R. E. GINNA NUCLEAR POWER PLANT

Amendment No. 16
License No. DPR-18

ATTACHMENT TO LICENSE AMENDMENT NO. 16

SAFETY EVALUATION BY THE OFFICE OF NUCLEAR REACTOR REGULATION
SUPPORTING AMENDMENT NO. 16 TO FACILITY OPERATING LICENSE NO. DPR-18

FIGURE 6.2-1

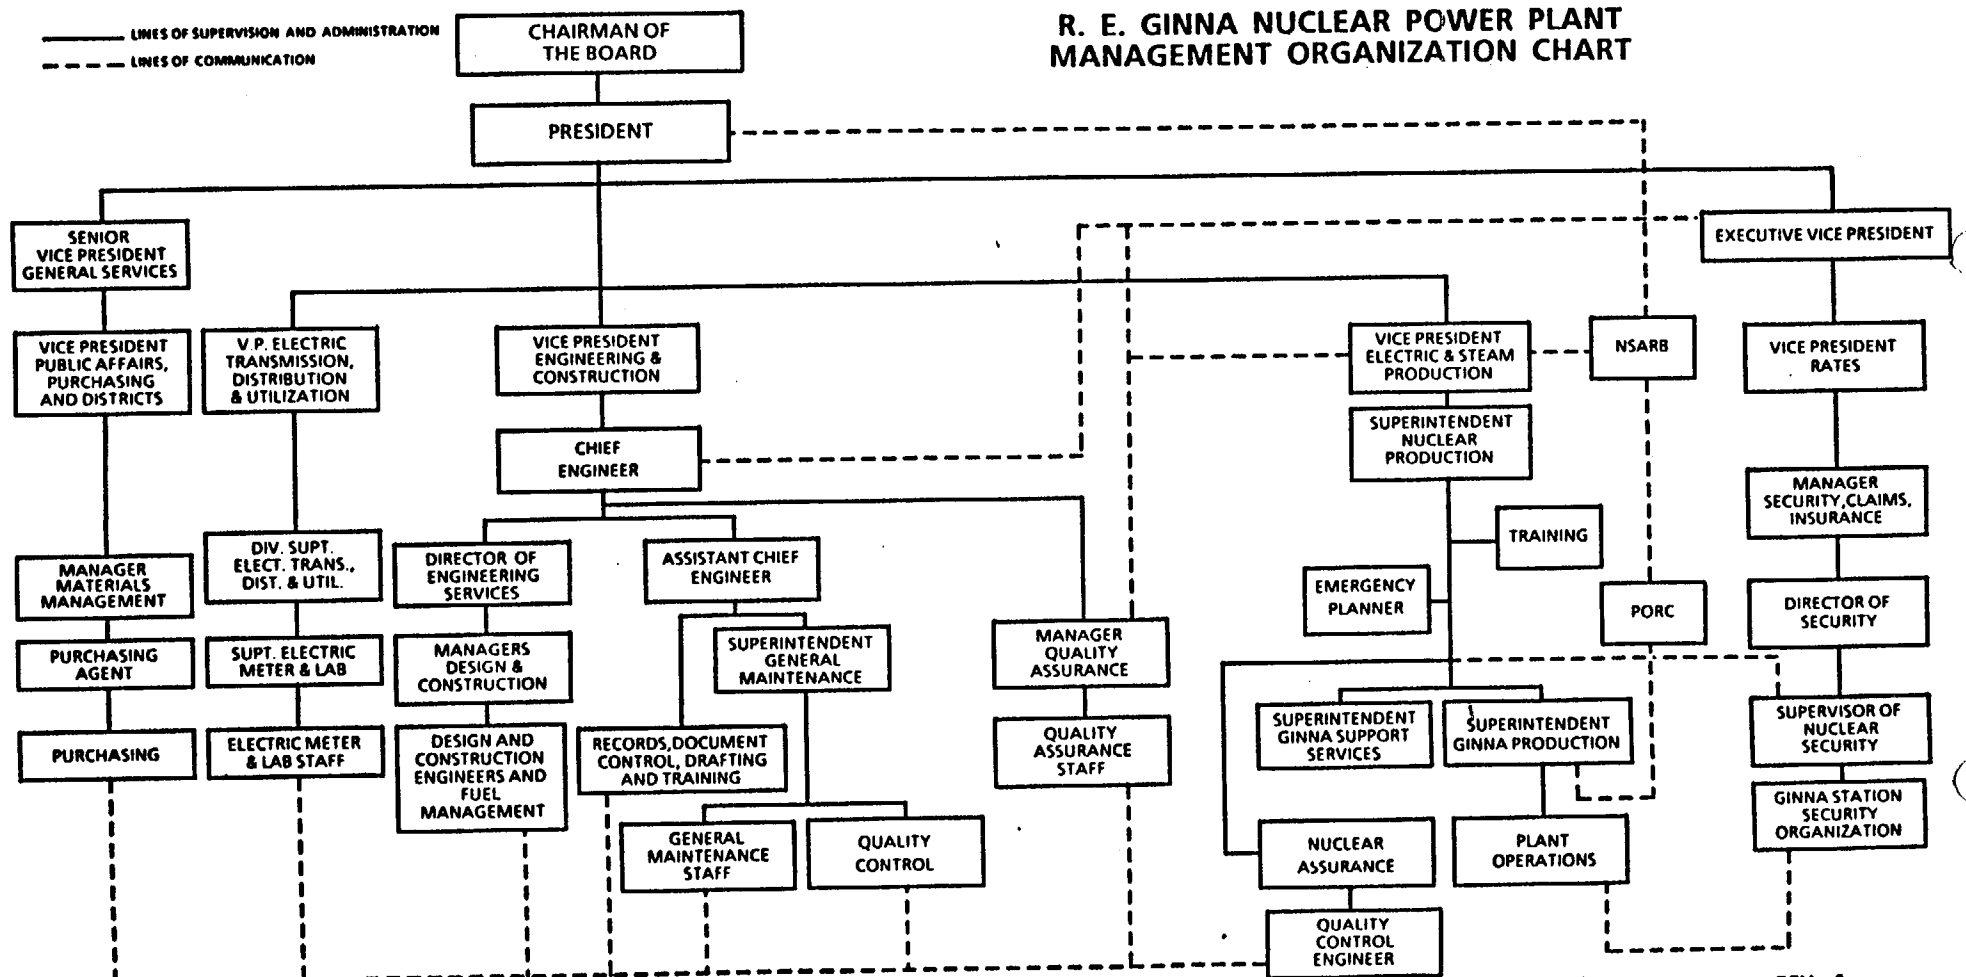
RG&E submitted this application to change the TS based on changes to the corporate management organization brought about by the sudden death of the Senior Vice President, Operations. Previously, Vice Presidents reported to the Senior Vice President, Operations, now they report directly to the President as the position of Senior VP, Operations has been removed from the corporate management organization. This change shortens the reporting path from the Manager, Quality Assurance to the upper corporate management levels and results in an increase in corporate attention to quality assurance. In addition, the Quality Assurance (QA) organization will now be a responsibility of the Executive Vice President. This change will make the QA organization independent of the design, construction and other engineering functions. We conclude that the corporate organizational changes as related to the QA organization provide more independence to the QA organization and also provide more direct upper corporate level management involvement and are therefore acceptable.

There are other changes in the plant organization. The Superintendent, Nuclear Production, the equivalent to a plant manager's position, now reports directly to the Vice President, Electric and Steam Production. Two new positions have been created, that of Superintendent-Ginna Production and Superintendent-Ginna Support Services, who report to the Superintendent, Nuclear Production. The new Plant Operations organization reports directly to the Superintendent-Ginna Production. The position of Assistant Superintendent has been eliminated. The Health Physics and Chemistry Manager, the Maintenance Manager, and the Operation Manager will report to the Superintendent-Ginna Production. The Technical Manager and the Materials Supervisor will report to the Superintendent-Ginna Support Services. We conclude that these changes will make the day-to-day operation of the station more effective by creating a group to concentrate on operations, maintenance and health physics and chemistry and are therefore acceptable.
